UNITED STATES PATENT AND TRADEMARK OFFICE

Office Action Summary

This is the second Office Action for serial number 10/039,573, Tool Hanger, filed on January 7, 2002. Claims 1-3, 8, 9, and 14 are pending.

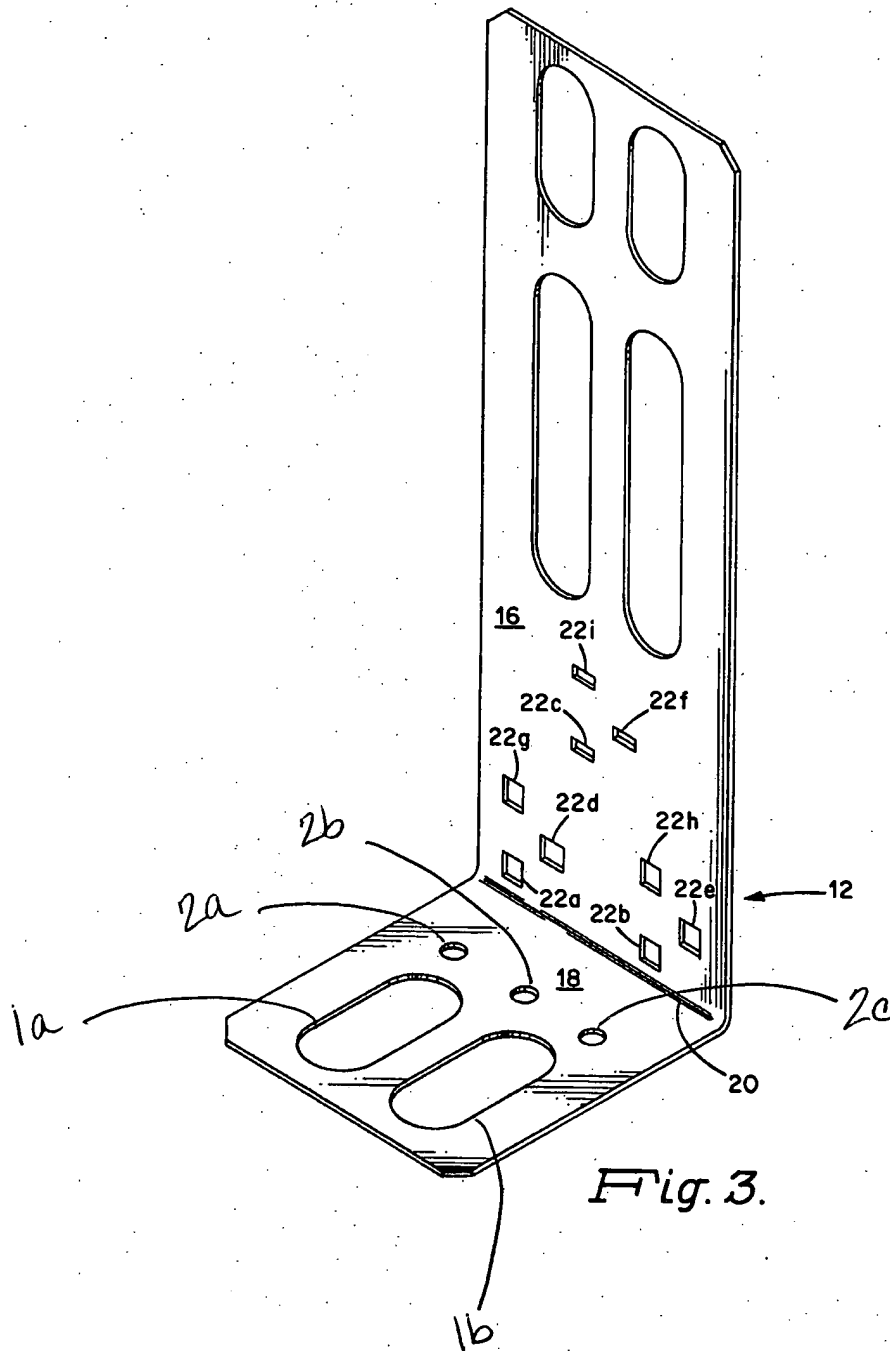
Claims 1, 2, 8, 9 and 14 are rejected under 35 U.S.C. 102(b) as being anticipated by U.S. Patent 4,447,030 to Nattel. Regarding claims 1, 2, 8, 9 and 14, Nattel discloses a hanger (see attached marked copy of Fig. 3) comprising: a horizontally oriented portion (18); a vertically oriented portion (12) joined to the horizontally oriented portion (18) at first ends thereof at a bend (at 20); and two or more non-axially aligned apertures (1a, 1b, 2a, 2b, 2c) located at a second end of the horizontally oriented portion (18), wherein two apertures are non-circular (1a, 1b) and wherein one aperture (2b) is located in the center of the second end, and wherein the apertures are dimensioned and spaced to permit secure connection to an object in two or more locations.

223,082

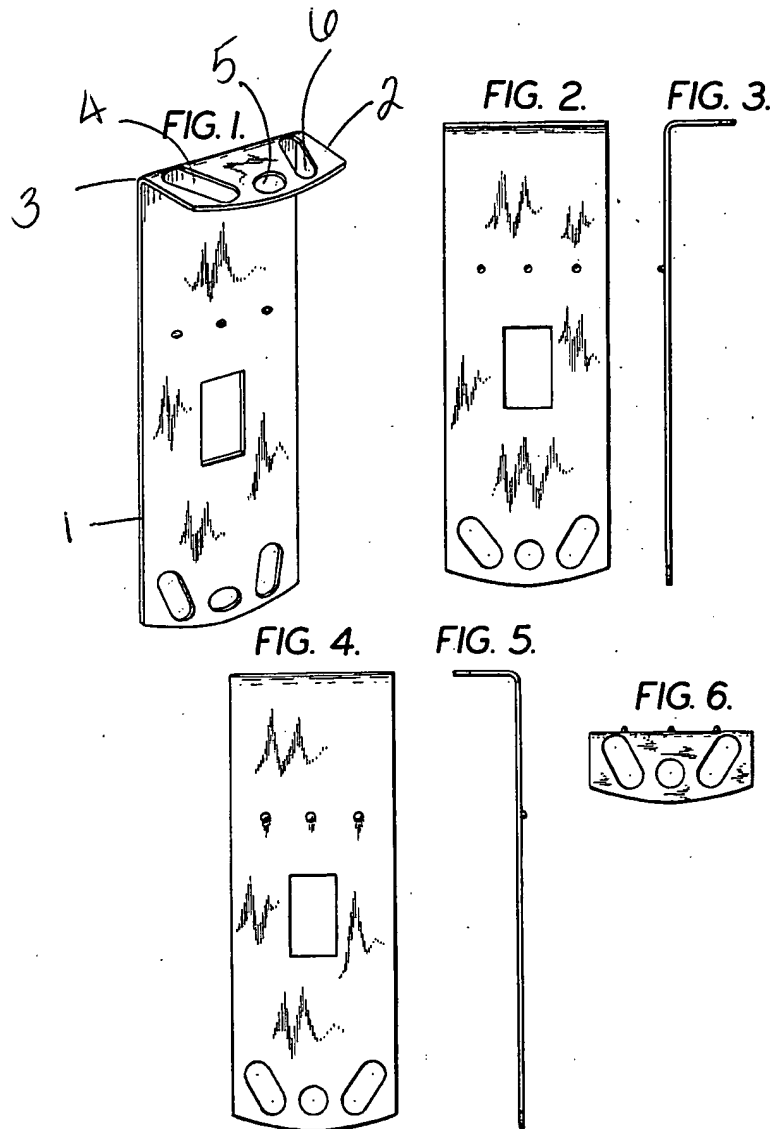
Claims 1, 2, 8, 9 and 14 are rejected under 35 U.S.C. 102(b) as being anticipated by U.S. Patent D223,082 to Fromm. Regarding claims 1, 2, 8, 9 and 14, Fromm

discloses a hanger (see attached marked copy of Fig. 1) comprising: a horizontally oriented portion (1); a vertically oriented portion (2) joined to the horizontally oriented portion (1) at first ends thereof at a bend (3); and two or more non-axially aligned apertures (4-6) located at a second end of the horizontally oriented portion (1), wherein two apertures are non-circular (4, 6) and wherein one aperture (5) is located in the center of the second end, and wherein the apertures are dimensioned and spaced to permit secure connection to an object in two or more locations.

Claim 3 is rejected under 35 U.S.C. 103(a) as being unpatentable over Fromm. With regards to claim 3, Fromm discloses the hanger as applied above, but does not disclose any of the apertures (4-6) being threaded. However, it would have been obvious to one of ordinary skill in the art at the time the invention was made to have modified the aperture (5) to be threaded because one would have been motivated to provide a means for securing alternative fasteners, such as screws or bolts, to the bracket since nails, screws, and bolts are well known for their use in the fastening art and the selection of any of these known equivalents and their complementary aperture to attach the bracket to an object would be within the level of ordinary skill in the art.
